IMPORTANT RETROFIT NOTICE

INFORMATION BULLETIN NO. 3

SUBJECT: CHANGES IN DESIGN OF DDO FRONT END LIFT SYSTEMS

SHEET NO. E0003-3	TITLE FRONT END LIFT MOUNTING BAR ASSEMBLY	DATE 5-22-54	R	J. N. FLETCHER & CO. 707 WEST 7TH STREET HAWAII
----------------------	---	-----------------	---	---

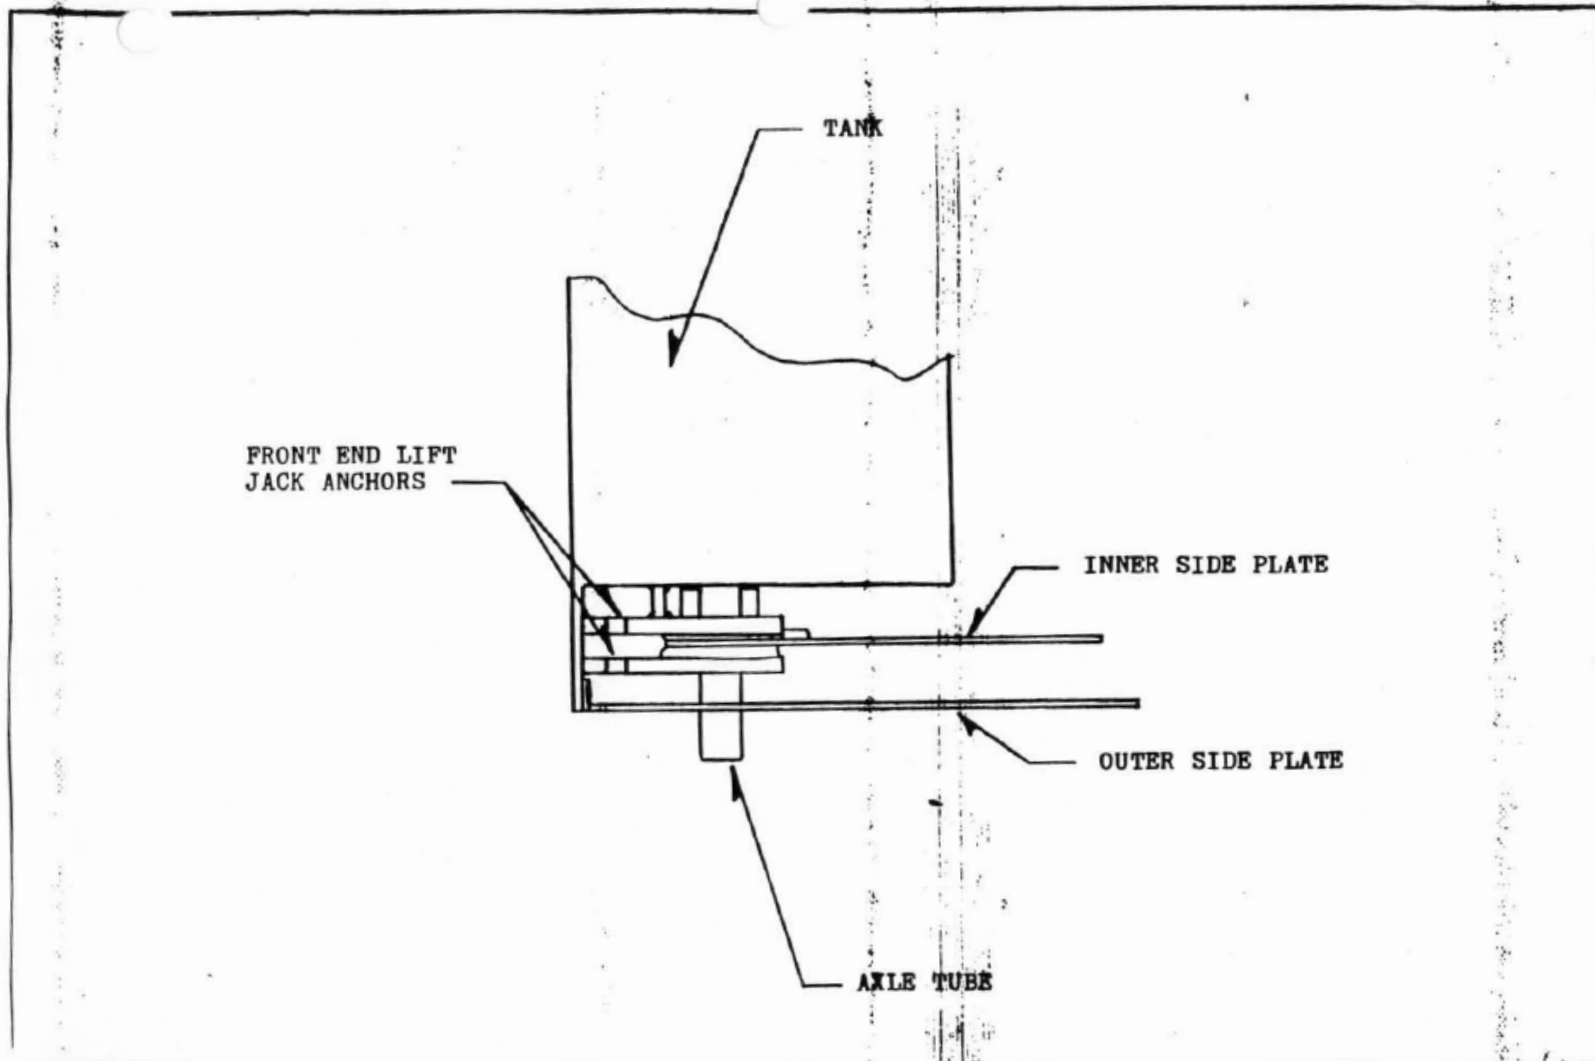
This improvement involves the design and material of the front end lift mounting ears.

Late in 1982, the material from which these ears are made was changed from hot rolled plate steel to U.S.S. T1 alloy plate.

The original design utilized two bolts to secure the retainer cap to the ear. The new design (see sheet no. B0003-3) used three bolts which are tack welded in place, plus a gusset plate between the retain and the ear on the top side.

Retrofit to this new design requires removing the front end, burning off the original mounting ears, welding on the new mounting ears, and reinstalling the front end assembly onto the chassis.

SHEET NO. B0003-1	TITLE FRONT END LIFT - OLD ARRANGEMENT	DATE 6-22-84	R	J. W. FLETCHER & CO. 707 WEST 7TH STREET HUNNERSVILLE, W. VA.
-----------------------------	--	------------------------	----------	---

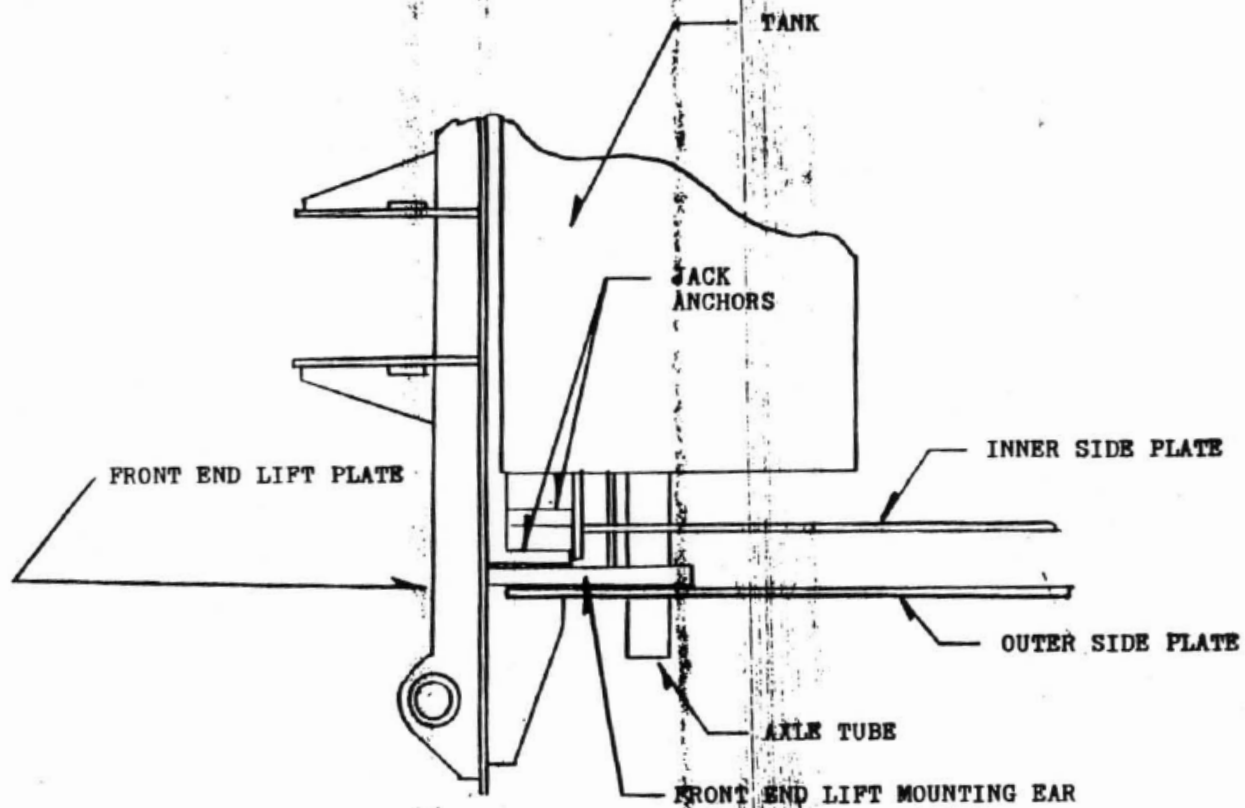
This improvement involves the manner in which the load is transferred from the jack anchors to the chassis. The original design (see sheet no. B0003-1) put the load directly on the bottom plate of the chassis through the 2" thick jack anchors. A vertical plate was welded onto the back edge of the jack anchors and tied into the side of the oil tank. With this arrangement, high stresses would occasionally occur in the frame bottom plate and/or oil tank.

SHEET NO.
B0003-2

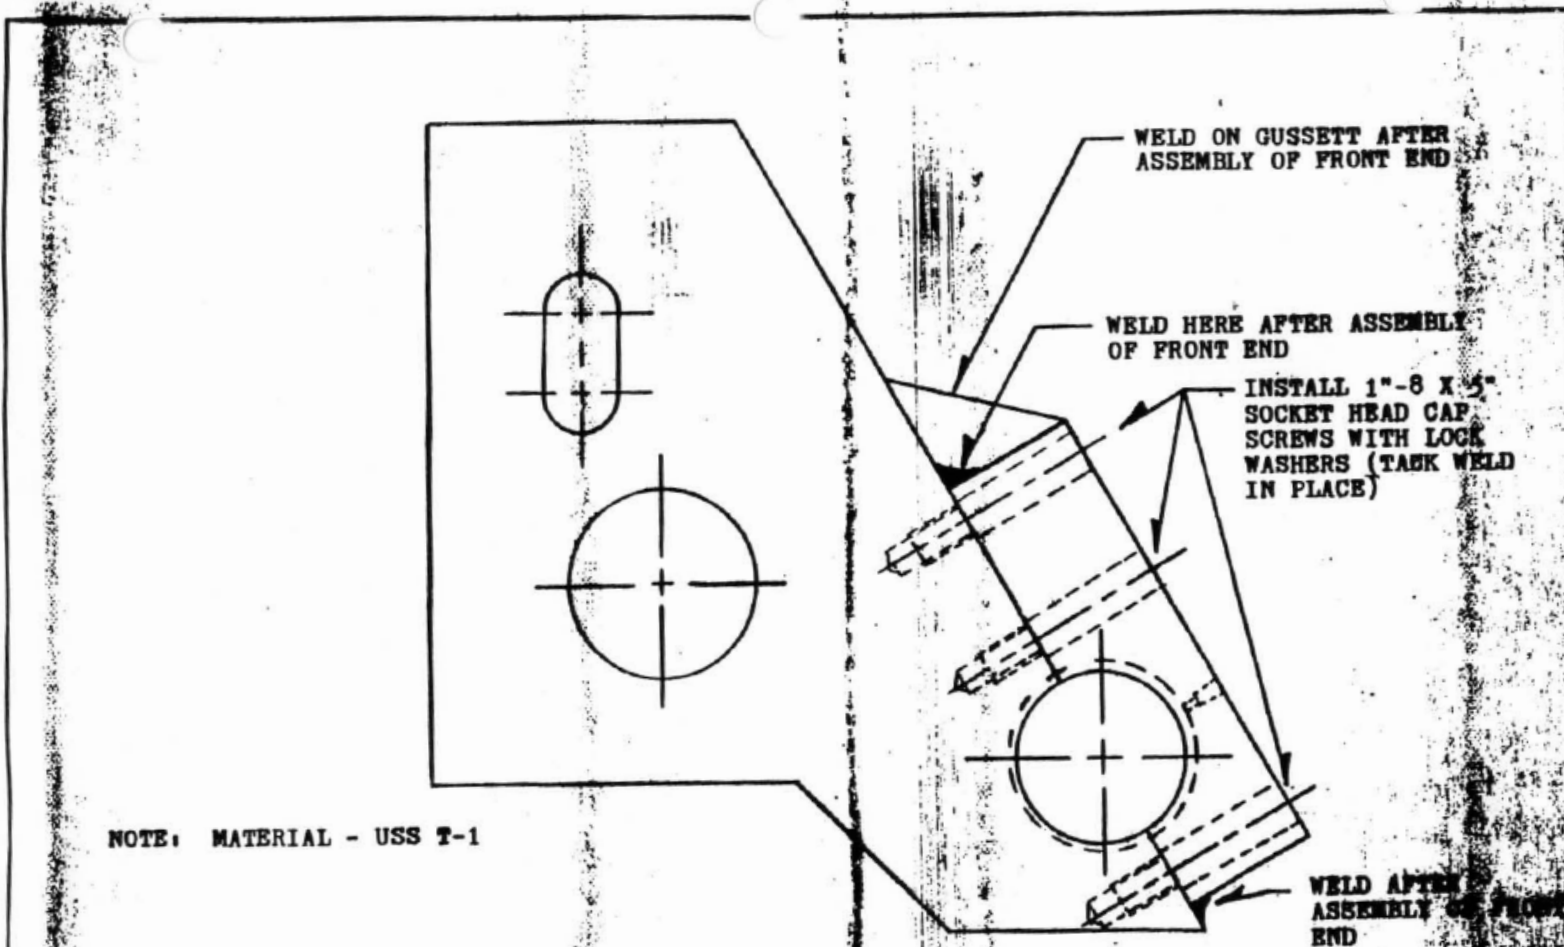
The new design (sheet no. B0003-2) transfers the load from the front end lift cylinders further back on the bottom plate of the chassis, around the axle tube, and into the inside chassis side plates.

Retrofit to this new design involves removing the front end, burning out the original jack anchors, welding in the new jack anchors and plates, and reinstalling the front end onto the chassis.
